Access Compliance Report

Public Rights-of-Way

(Curb Ramps)

Intersection ID: 22223	Main Street: HUCKLEBERRY_RD	Cross Street: STOCKTIE_RD	Location: W
ADA ID: 8934C60EE5A4	Ramp Type: PerpDiag	Initial Pass/Fail: Fail	Overall Compliance: No
Severity Score: 58.75			
Codes/Mitigation Info/Possible Solution		Field Measurements/Component Compliance

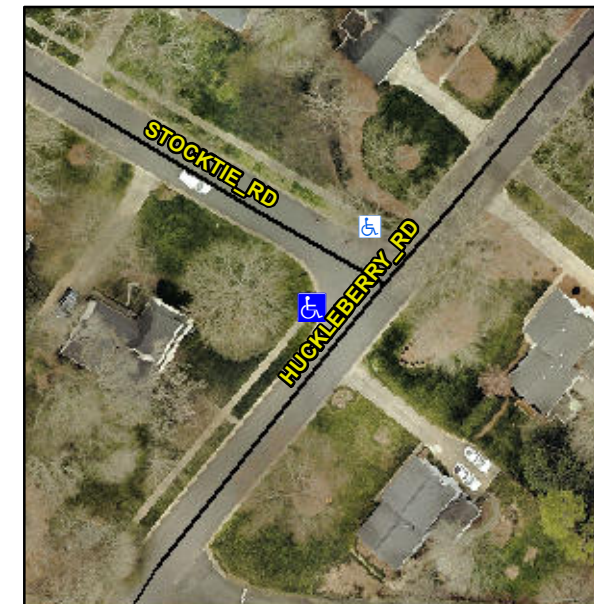
Not Found, R304.5.1, R304.2.2, R304.5.3

Compliance	Description	Data	Compliance	Description	Data
N/A	Ramp Length (in)	69.0	No	Ramp Slope (%)	12.1
No	Ramp Width (in)	39.0	No	Ramp XSlope (%)	8.9
N/A	Flare Type LT	N/A	N/A	Flare Type RT	N/A
N/A	Flare Slope LT (%)	N/A	N/A	Flare Slope RT (%)	N/A
N/A	Flare Traversable LT?	N/A	N/A	Flare Traversable RT?	N/A
N/A	Landing Length (in)	N/A	N/A	DWS Provided?	N/A
N/A	Landing Width (in)	N/A	N/A	DWS Contrast?	N/A
N/A	Landing Slope (%)	N/A	N/A	DWS Length (in)	N/A
N/A	Landing X Slope (%)	N/A	N/A	DWS Full Width?	N/A
N/A	Landing Curb? (Y/N)	N/A	N/A	DWS Offset (in)	N/A
N/A	Shared Landing?	N/A			
N/A	Gutter Ponding?	N/A	N/A	Gutter Slope (%)	N/A
N/A	Gutter Lip Ht (in)	N/A	N/A	Gutter X Slope (%)	N/A
N/A	Painted X Walk1?	No	N/A	Painted X Walk2?	No
	X Walk 1 Direction	To SE		X Walk 2 Direction	To NE
N/A	X Walk 1 Width (in)	N/A	N/A	X Walk 2 Width (in)	N/A
	X Walk 1 Slope (%)	2.6		X Walk 2 Slope (%)	3.7
	X Walk 1 X Slope (%)	2.9		X Walk 2 X Slope (%)	4.2

Remove & Replace Curb Ramp With Two New Directional Ramps or Equivalent.
